Potential Groundwater and Surface Water Impacts from the Proposed Dawson Gold Mine, Fremont County, Colorado, USA

Steven H. Emerman, Ph.D., Malach Consulting, LLC, 785 N 200 W, Spanish Fork, Utah 84660, USA, Tel: 1-801-921-1228, E-mail: SHEmerman@gmail.com

Report written for Information Network for Responsible Mining, submitted August 25, 2021

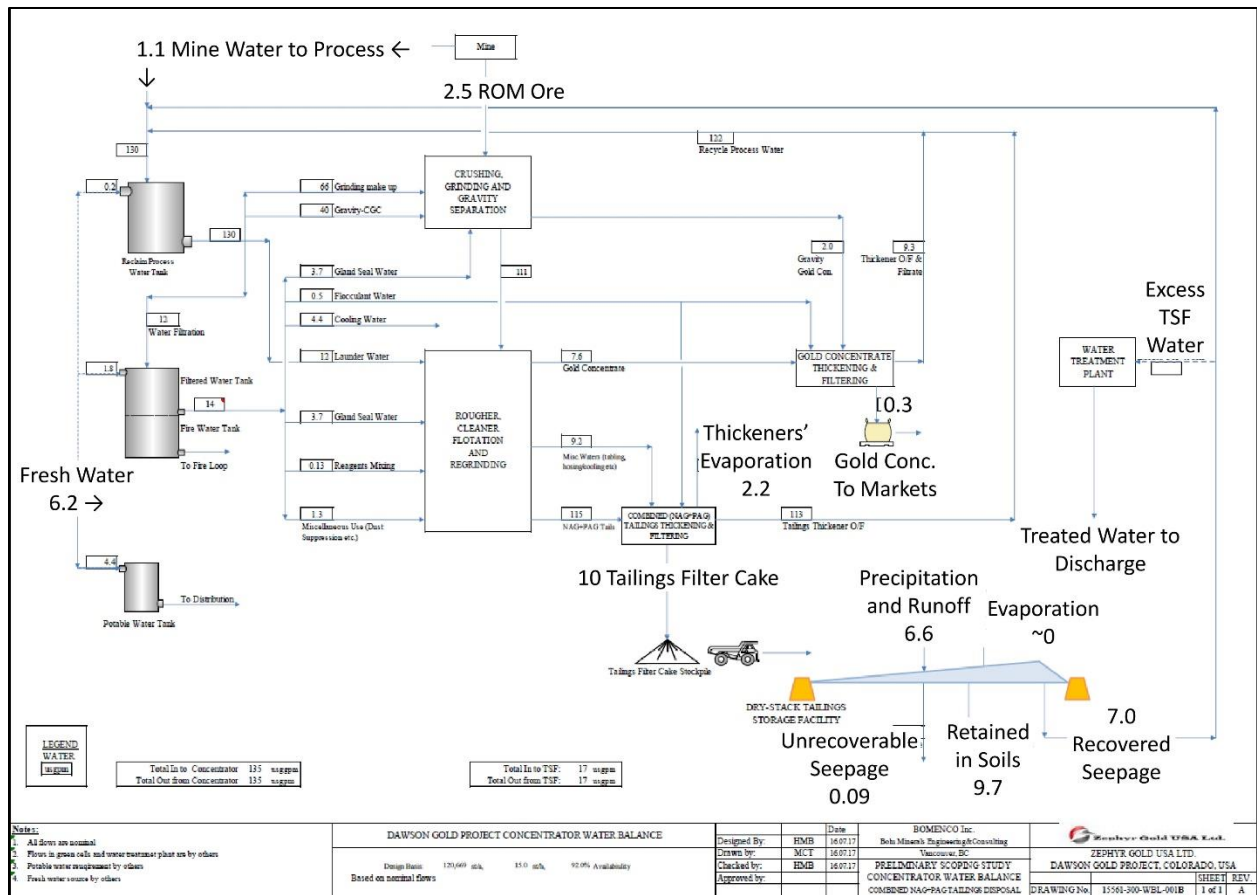
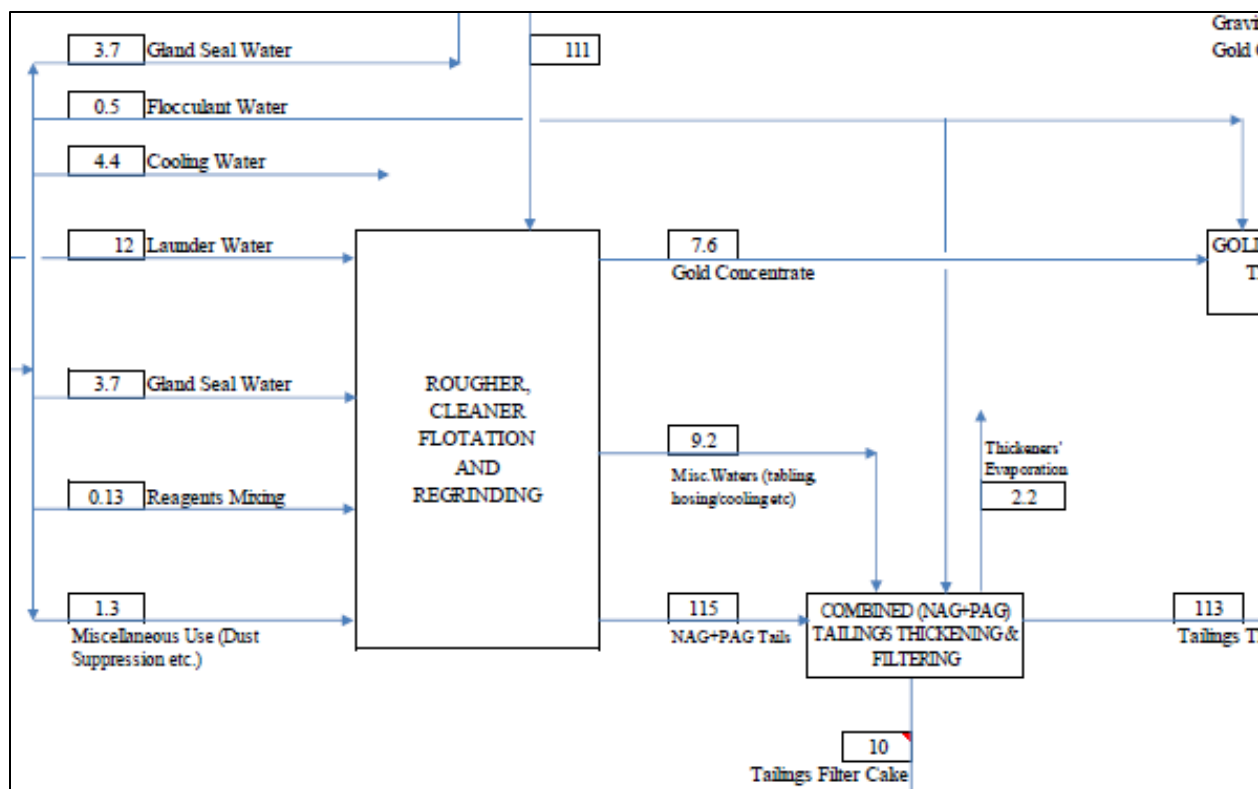
The absurdity of the very low evaporation rate (and of assigning all evaporation to the tailings thickener) is also indicated by the assumption that there will be no evaporation of the water used for cooling (4.4 gpm) and dust suppression (1.3 gpm) (see Fig. 8b). Although the arrow labeled “Cooling Water” does not end anywhere (suggesting that it is lost to evaporation), both cooling water and water for dust suppression must enter the box “Rougher, Cleaner Flotation and Regrinding” in order to balance the inputs and outputs from the box. The inputs to the flotation and regrinding box are output from the box “Crushing, Grinding and Gravity Separation” (111 gpm), cooling water (4.4 gpm), launder water (12 gpm), gland seal water (3.7 gpm), reagents mixing (0.13 gpm), and miscellaneous use (dust suppression, etc.), totaling 132.53 gpm (see Fig. 8b). The outputs from the flotation and regrinding box are gold concentrate (7.6 gpm), miscellaneous waters (tabling, hosing/cooling, etc.) (9.2 gpm), and NAG + PAG tails (115 gpm), totaling 131.8 gpm (see Fig. 8b). The water balance is still not perfect (input exceeds output by 0.73 gpm), but evaporating the cooling water and dust suppression water before it enters the flotation and regrinding box would require the generation of 4.97 gallons per minute within the flotation and regrinding box.

In the same way, the water balance assumes that the miscellaneous waters (including water for hosing and cooling) enter the box “Combined (NAG + PAG) Tailings Thickener & Filtering” with no loss due to evaporation (see Fig. 8b). The inputs to the tailings thickener box

are miscellaneous waters (9.2 gpm), NAG + PAG tails (115 gpm), and flocculant water (0.5 gpm), totaling 124.7 gpm (see Fig. 8b). The outputs from the tailings thickener box are tailings filter cake (10 gpm), tailings thickener O/F [overflow] (113 gpm) and thickeners' evaporation (2.2 gpm), totaling 125.2 gpm (see Fig. 8b). Again, the water balance is not perfect (output exceeds input by 0.5 gpm), but evaporating the hosing/cooling water before it enters the tailings thickener box would require the generation of 9.7 gallons per minute within the tailings thickener box.

Although the water balance diagram (see Fig. 8a) shows a "Water Treatment Plant" before "Treated Water to Discharge," the available documents do not include any plan for a water treatment plant, including no discussion of the contaminants that would need to be removed or how they would be removed. According to Environmental Alternatives (2021a), "Contact water in the contact water pond is expected to meet groundwater quality standards and, therefore, will not require treatment prior to discharge." However, the accompanying appendices

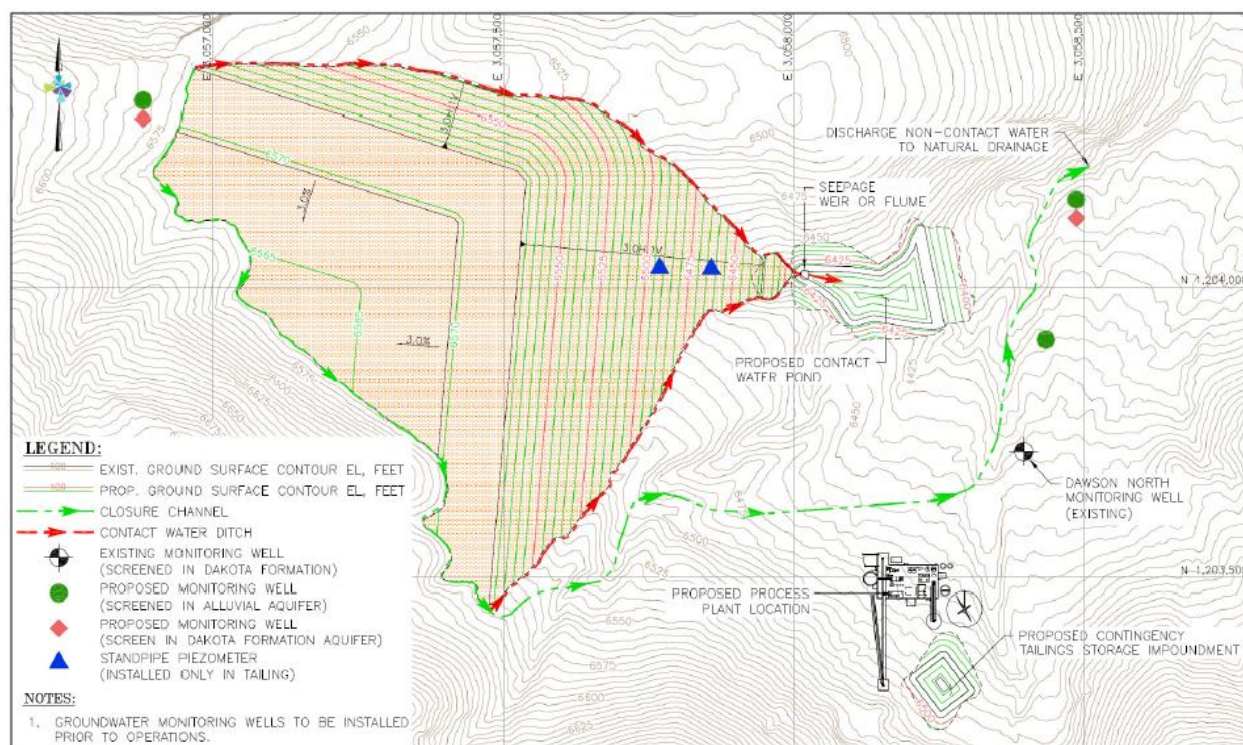
The purpose of the diversion channels (contact water ditches) is to prevent rewetting of the filtered tailings by surface runoff (see Fig. 9). The design of the channels to accommodate a

24-hour storm with a return period of 10 years during mine operation means that, in any given year, the probability of overtopping of the channels will be 10%. On that basis, the probability that overtopping of the channels will occur at least once during the five years of mine operation is 41%, so that overtopping of the channels will essentially be an expected event. The available documents include no discussion of the consequences of overtopping of the diversion channels, including possible impacts on the stability of the filtered tailings facility or the possibility of liquefaction of the lightly-compacted tailings.

The design of the channels to accommodate a 24-hour storm with a return period of 100 years after mine closure means that, in any given year of the indefinite time period following mine closure, the probability of overtopping of the channels will be 1%. On that basis, the probability that overtopping of the channels will occur at least once during, say, the next 60 years (two human generations), is 45%, so that overtopping of the channels will essentially be an expected event for the grandchildren of the current residents of Cañon City. As before, the available documents include no discussion of the consequences of overtopping of the diversion channels, including possible impacts on the stability of the filtered tailings facility or the possibility of liquefaction of the lightly-compacted tailings. In summary, the proposed water management infrastructure for the filtered tailings facility is entirely inadequate.

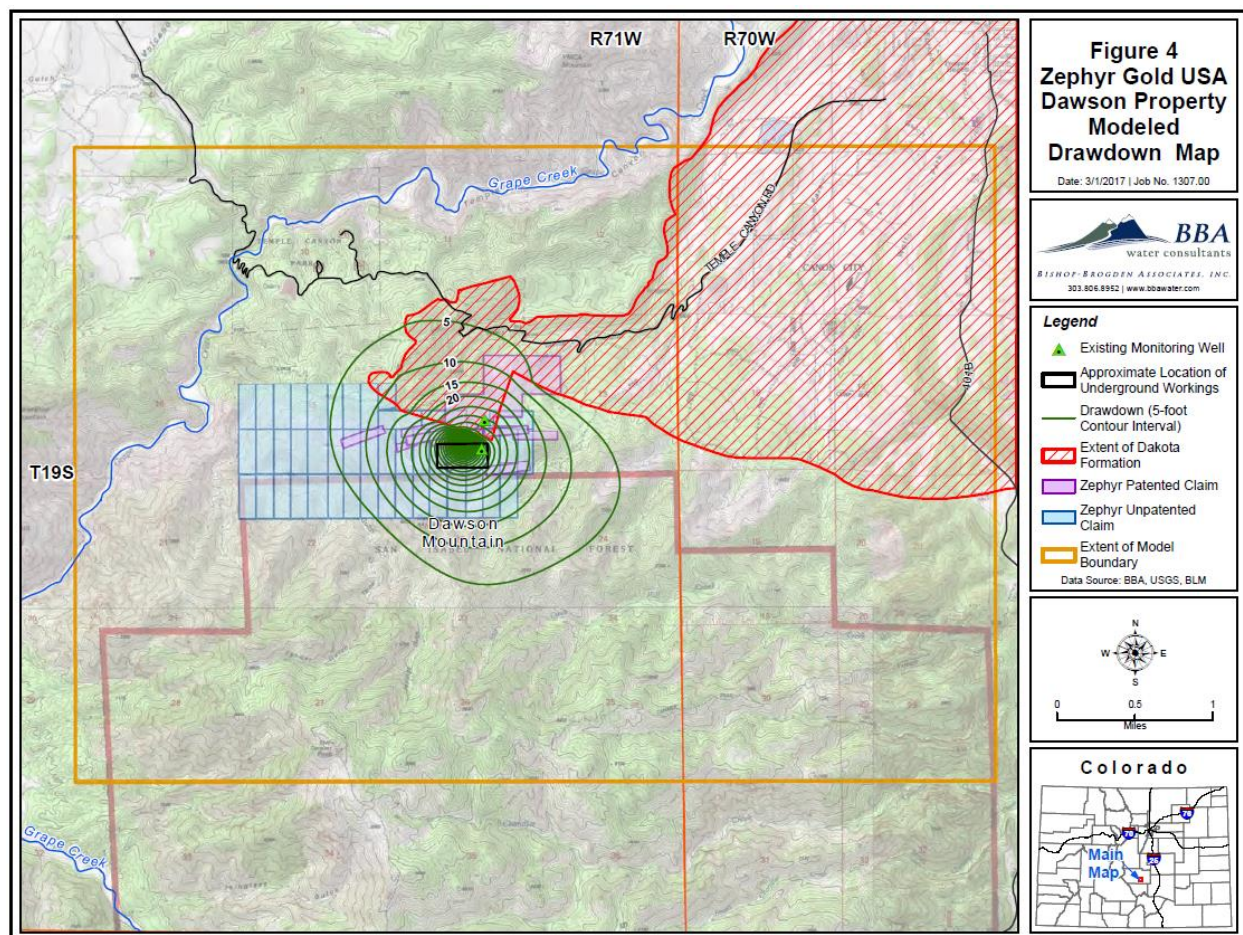
The groundwater impacts from the mining operation seem minor (Environmental Alternatives, 2021b), but they are based only upon the impact of dewatering of the underground mine and do not include the regional drawdown that could be caused by pumping the supply well. There is no information about the location or the depth of the supply well, so that it is not possible to calculate the additional drawdown due to the supply well. As explained in the previous subsection, a pumping rate on the order of 100 gallons per minute is much more likely. In summary, the actual groundwater impacts of the Dawson gold mine are entirely unknown at the present time.

It is also noteworthy that the groundwater impacts from mine dewatering were projected only for a 10-year period (Environmental Alternatives, 2021b). No attempt was made to calculate the long-term impacts of dewatering or the time required to restore the equilibrium of the groundwater system. According to Environmental Alternatives (2021b), "An isotropic hydraulic conductivity of 0.02 feet per day was used for the hard rock based on a review of limited well test data from State well completion reports and the potential range of fractured hard rock hydraulic conductivities." Such low hydraulic conductivities could mean that the filling of the underground excavation with groundwater could have only just begun at the end of the 10-year hydrogeologic modeling period. Since the underground excavation must eventually fill with water, the long-term regional drawdown of groundwater could extend for a considerable, but unknown, time into the future.

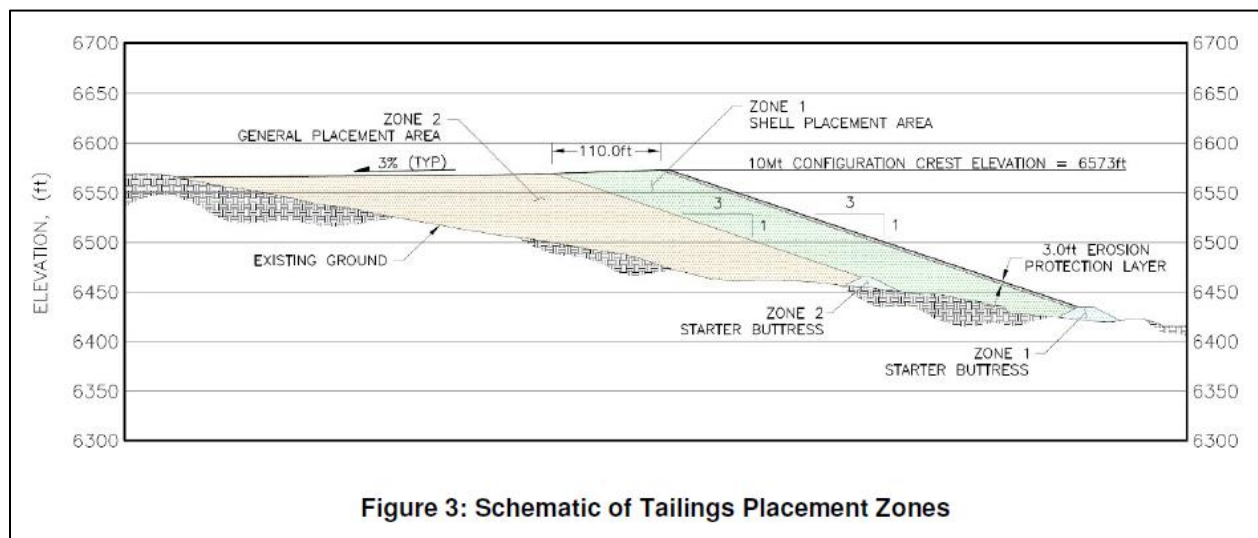
The documents from Zephyr Minerals Ltd do not include any discussion of the circumstances under which liquefaction of the filtered tailings could occur. According to Environmental Alternatives (2021b), “The Dawson tailings will be compacted to an unsaturated state of 95% of the standard Proctor maximum dry density in the perimeter shell. Such densely compacted tailings will dilate, or increase in volume, when sheared, essentially resulting in a decrease in pore water pressures, therefore tailings in the perimeter shell are not considered to be susceptible to liquefaction.” However, even after the initial compaction of the tailings, it is still necessary to consider possible sequences of events under which the tailings could become resaturated through precipitation or surface runoff or by the weight of overlying tailings. Moreover, the most important consideration is not the possible liquefaction of the tailings making up the structural zone/dam, but the possible liquefaction of the lightly-compacted tailings that would be confined by the structural zone/dam (see Fig. 11). In this respect, there has not even been any consideration as to the particle size distribution of the tailings, which would be a starting point toward evaluation as to whether the tailings would be susceptible to liquefaction. As mentioned earlier, tailings with a mix of fine and coarse particles will tend to be susceptible to liquefaction, since the finer particles will fill the spaces between the coarser particles and prevent the escape of water during deformation.

Since the possibility of liquefaction of the lightly-compacted tailings in Zone 2 General Placement Area cannot be dismissed without further investigation, it is important to note that the structural zone (the dam) would be constructed on top of the lightly-compacted tailings (see Fig. 11), which is known as the method of upstream construction. The method of upstream construction is the cheapest method of dam construction because it uses the minimum amount of construction material (in the case of the Dawson mine, tailings with an appropriate water content for adequate compaction). On the other hand, the method of upstream construction is the most dangerous because, if the underlying tailings undergo liquefaction, the dam will simply fall backwards and downwards into the liquefied tailings, even if the dam itself does not liquefy. For this reason, the method of upstream construction for tailings dams is illegal in Brazil (Agência Nacional de Mineração [National Mining Agency], 2019), Chile (Ministerio de Minería (Chile) [Ministry of Mining (Chile)], 2007), Ecuador (Ministerio de Energía y Recursos Naturales No Renovables (Ecuador), 2020b) and Peru (Sistema Nacional de Información Ambiental (Perú) [National System of Environmental Information (Peru)], 2014).

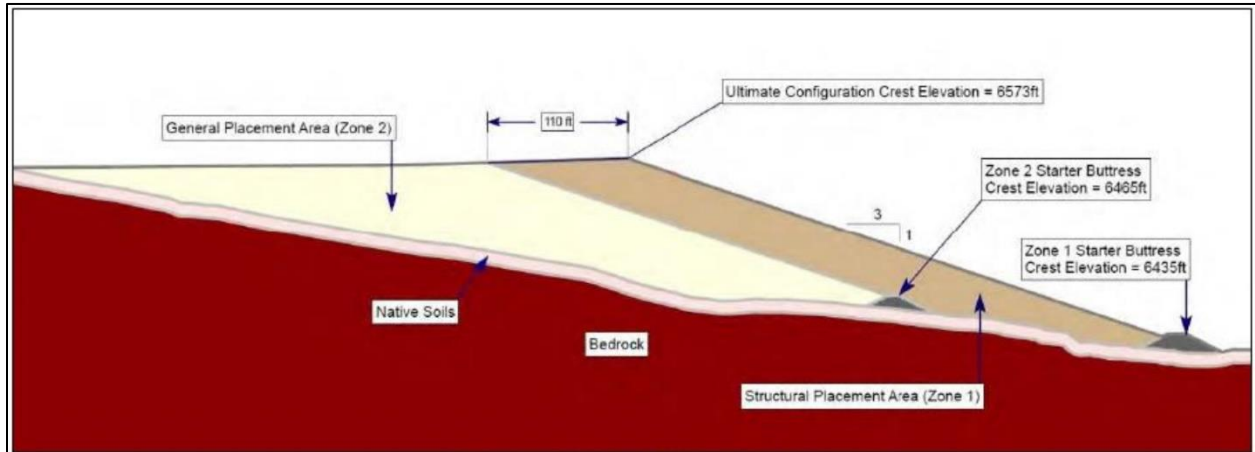
Although the static stability analysis indicates an acceptable factor of safety ($FS > 1.5$), the stability analysis was not based upon any measurements of the actual materials that would make up the filtered tailings storage facility or its foundation (see Fig. 14). The only explanation for the choices of parameters was the statement “The unit weight of the structural and general placement areas were derived from Proctor tests and based on the design criteria stating that the shell and general placement areas must be 95% and 90% of the standard Proctor maximum dry density, respectively. All materials, except for the zone of general placement filtered tailings (Zone 2), were assigned effective strength (i.e., drained) properties. The general placement tailings were conservatively assigned an undrained shear strength ratio (S_u/σ'_v) of 0.35.” There was no explanation for the choices of any of the shear strength parameters or any of the properties of the bedrock, native soils or rockfill. Moreover, the unit weights (densities) were obtained from tailings from a different ore deposit, not the deposit that would be extracted by the Dawson gold mine. According to Environmental Alternatives (2021b), “For this study, one composite synthetic tailings sample was generated from 60 core samples obtained from exploration drilling of the Windy Gulch deposit. Geotechnical classification testwork and geochemical characterization were conducted on the tailings sample. As no tailings sample was available from the Dawson Segment, the properties of the Windy Gulch tailings sample were assumed for the design of the FTSF.”

The Summary of Material Parameters for Stability Analyses in Environmental Alternatives (2021b) refers to the values of 105 and 100 pounds per cubic foot for the filtered tailings in Zones 1 and 2, respectively, as the moist unit weight, meaning that the weight includes the weight of the entrained water (see Fig. 14). However, the same document repeatedly refers to the same values as dry densities or dry unit weights, meaning that the weights do not include the weight of entrained water. For example, Environmental Alternatives (2021b) states “Specifically, the following assumptions and design criteria were applied: In-place tailings dry density = 105 pcf for Zone 1 – Shell Placement Area and 100 pcf for Zone 2 – General Placement Area.” If the static stability analysis is using 100 and 105 pounds per cubic foot as moist unit weights when those values are actually dry unit weights, then the static stability analysis is underestimating the gravitational stress on the filtered tailings facility. For that reason alone, the calculation of the factor of safety would be an overestimate.

Nothing in the discussion of the static stability analysis states the assumed height of the water table within the filtered tailings facility. In this respect, in such a dry environment, a water table (top of the region with saturated pores) within the filtered tailings facility would result probably not from naturally occurring groundwater, but from the water entrained within the filtered tailings, as well as from precipitation and surface runoff onto the filtered tailings facility. There is no discussion of the water table height that would result in the factor of safety dropping below $FS = 1.5$ nor the circumstances under which such a water table height could develop. In summary, although the static stability analysis indicates an acceptable factor of safety, the analysis should be regarded as entirely unreliable.
